MWO 9-1005-201-30-5

MODIFICATION WORK ORDER

**MODIFICATION OF MACHINE GUN, 5.56MM, M249
(NSN 1005-01-127-7510)**

21 May 1997

Figure 1.

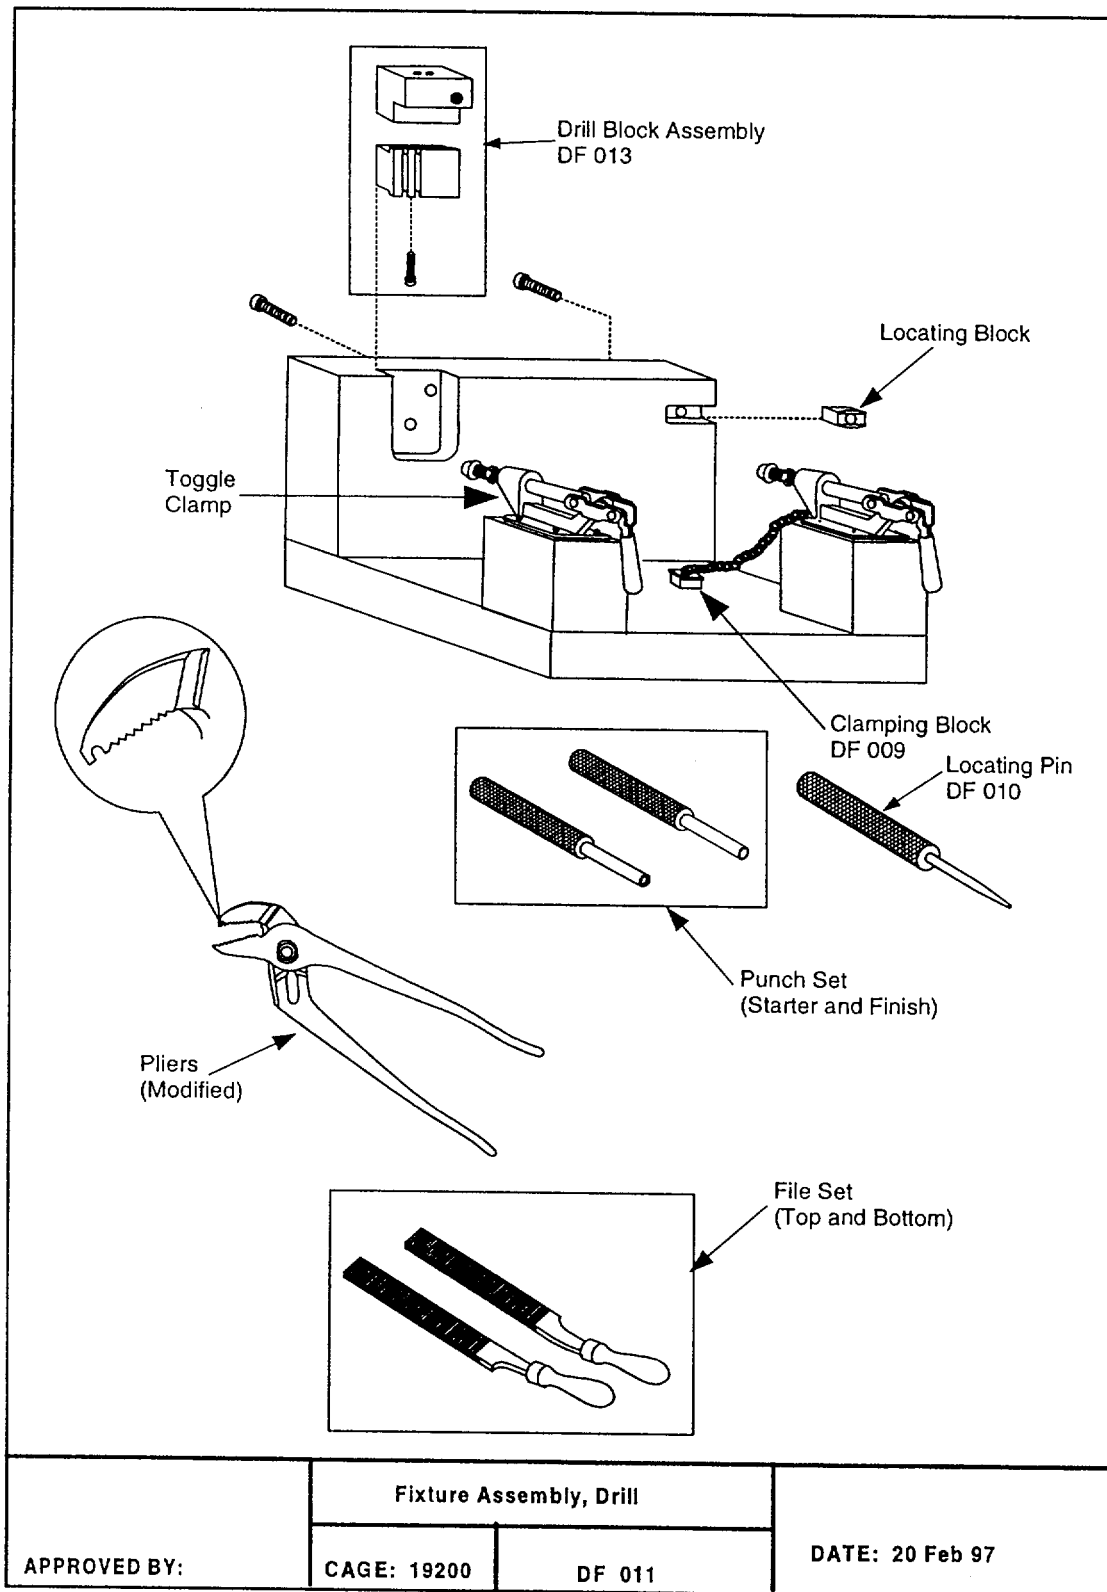
b. Special tools (furnished with modification kit drilling fixture, see Figure 1):

d. Jigs (furnished with modification kit drilling fixture, see Figure 1):

(1) Drill Fixture (Fixture, Assembly, Drill, see figure 1), part number DF 011, NSN 1005-01-442-4811, provides capabilities of locating, clamping, reaming, and drilling receivers.
